EMORANDUM

DATE: November 3, 2015

SUBJECT: BZA No. 19103 – Area Variance and Special Exception relief requested for construction of a new building at 901 5th Street, NW – Square 516, Lot 59

Figures 1 and 2. Site and locations for which Closed Court; Rear Yard, and Parking variances are requested

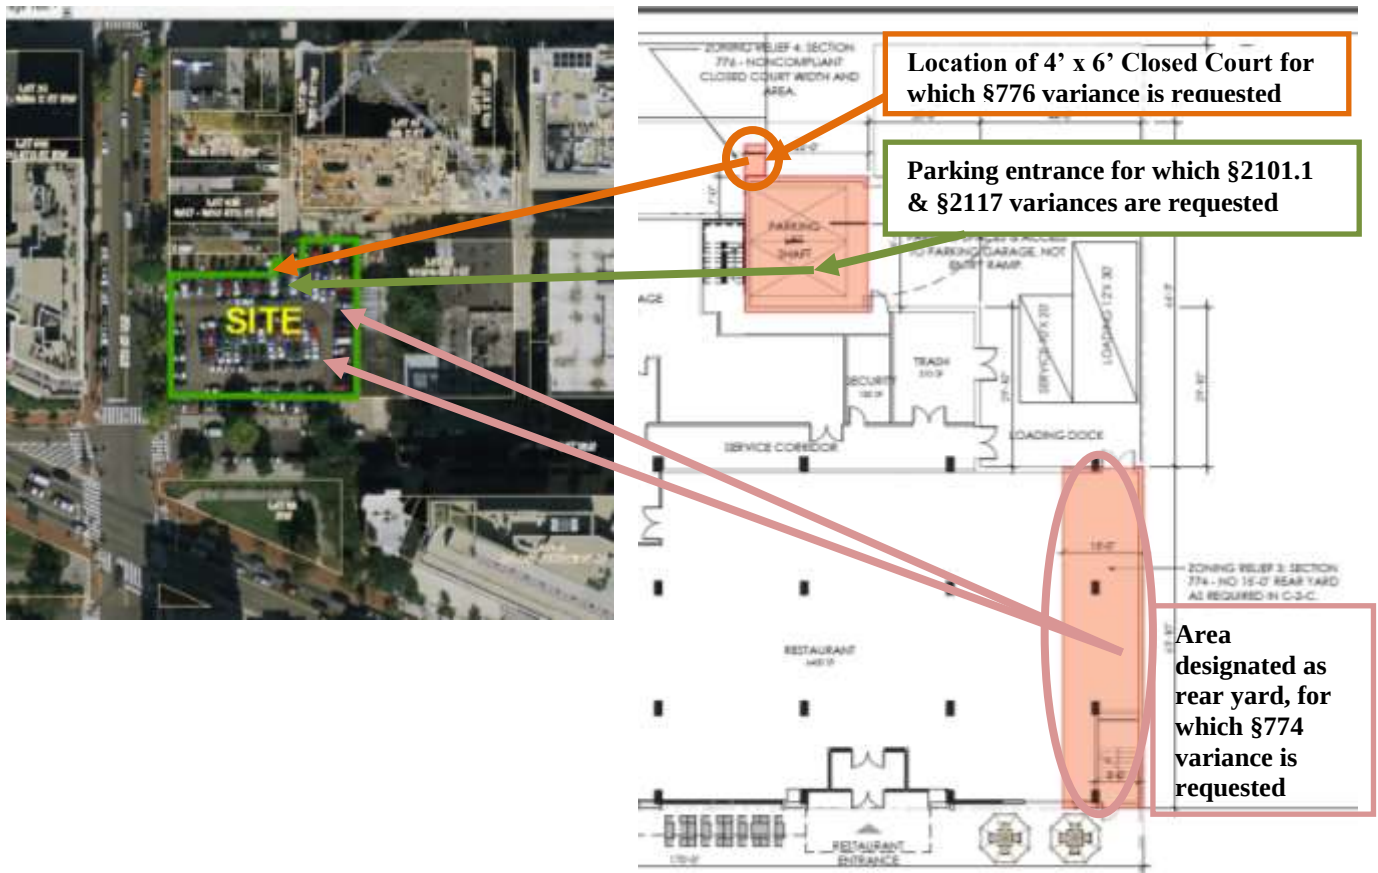
§ 774.1 -- Rear Yard

The applicant has demonstrated that the site's relatively small size for a downtown location and its irregular northern boundary results in a practical difficulty in meeting the requirement to provide a rear yard on this lot, particularly given the core-factor requirement for the desired mixed use development.

The applicant has demonstrated that with 5th Street being considered the front of the building, the provision of a rear yard to the east would result in a 15 foot wide and 130 foot tall gap in the streetwall on I Street. The site is a corner property within the Mount Vernon Triangle historic district (the historic district) and the Mount Vernon Triangle sub-area of the Downtown

Development District (the Triangle). Such a gap would be inconsistent with the traditional building pattern in the historic district. OP notes that if I Street, rather than 5th Street, were to be considered the front of the building the provision of a rear yard to the north would result in a 15 ft. gap in the 5th Street streetwall. This would be inconsistent with not only the historic district pattern but also with the Triangle's design principles which, as codified in 11DCMR § 1722, stress the importance of continuous ground floor frontages on 5th Street.

§ 776.1 and 776.2 Width and Area of Closed Court

The applicant has demonstrated that the unusual shape of the northern lot line would lead to a practical difficulty in meeting the closed court regulations were strictly applied. For a 4 foot wide section of the northern lot line, the boundary jogs 6 feet deep into the lot to the north. It would be impractical to fill in this 24 square foot area to the building's height of 130 feet. It would result in either a solid block of construction material or an unusable interior space that would be approximately 2 feet wide, 5 feet deep and 130 feet high. The alternative -- provision of an 884 square foot, 130 foot high closed court open to the air -- would negatively impact the interior layout of the ground floor open air and would create an unusable and difficult to maintain exterior space when the property to the north is developed and an additional wall is created for the court.

Figure 3. Roof Structure Relief

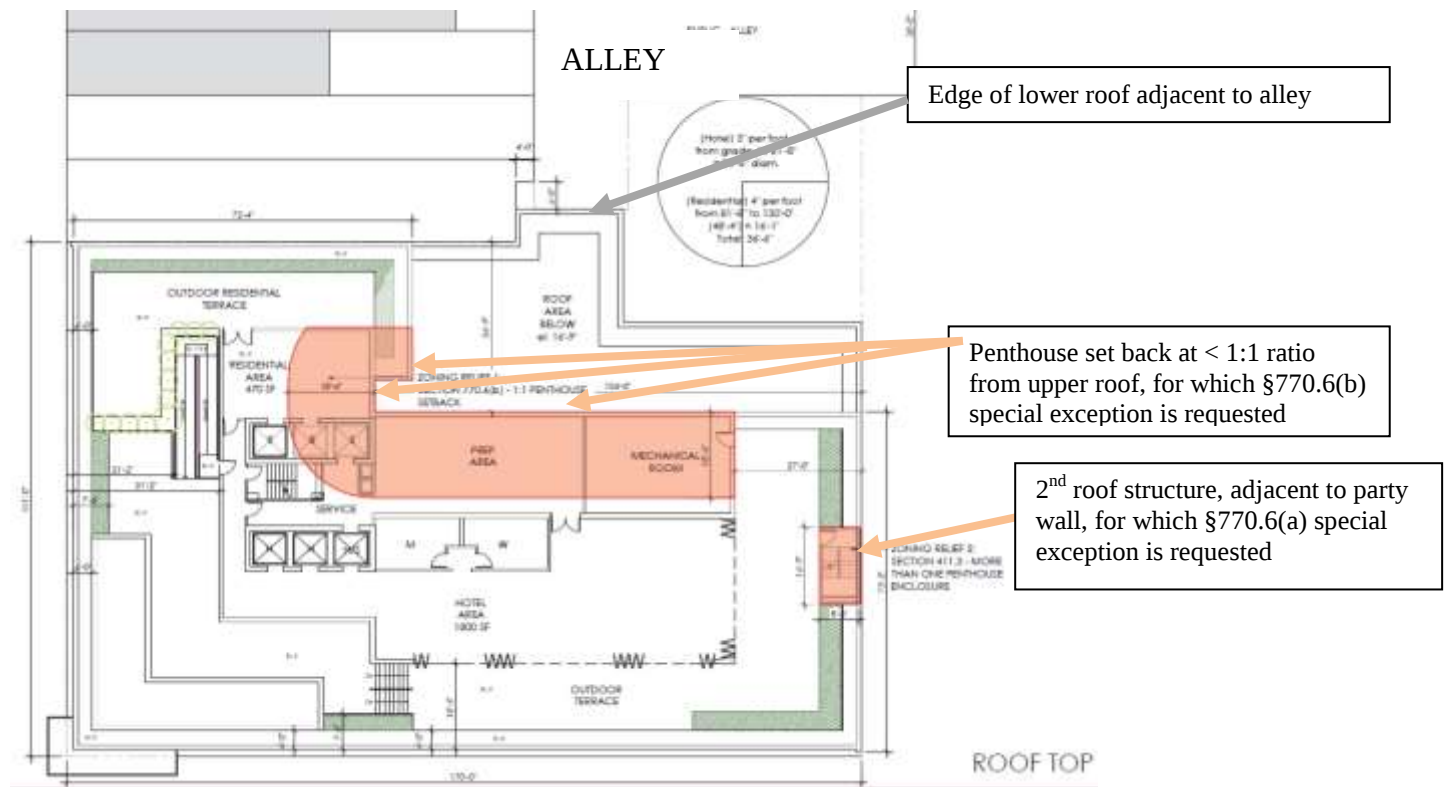
§§ 411 and 770.6(s): Number of Roof Structures

Yes. The applicant has demonstrated that the additional roof structure is necessary to meet code requirements for secondary egress from a roof deck providing access for recreational or other purposes and that requiring it to be connected to the principal roof structure would result in the loss of green roof and in an increased mass for the roof structure.

§§ 411 and 770.6(b): Roof Structure Setback

Yes, the applicant has demonstrated that full compliance would result in operating difficulties and unreasonable modifications to the building plans. The applicant's architectural drawings illustrate that providing a 1:1 setback from the northern wall of the top story of the building would require the relocation of the elevator core, which would negatively impact corridor widths and parking aisle widths on the western side of the building, reducing the number of hotel rooms and parking spaces that could be provided, and potentially reducing the number of two-bedroom units.

No. Granting the requested relief for the addition would not impact the light and air of adjacent buildings. The side property line of the nearest building to the north would be at least 37 feet from the edge of the proposed roof structure.

No. The Zoning Administrator has determined that the exterior walls on the north side of the building consist of the walls that are closest to, but removed from, the northern property line. These walls are located in the northwestern portion of the site and are illustrated on pages 13 and 14 of the architectural drawings submitted with the applicant's pre-hearing statement. The walls from which the applicant has requested setback relief are approximately 37 feet back from these exterior walls. Granting setback relief from what the Zoning Administrator has determined, under the current regulations, to be non-exterior walls would not materially impair the intent and purpose of the zoning regulations and would further the efficient layout and use of the proposed building.
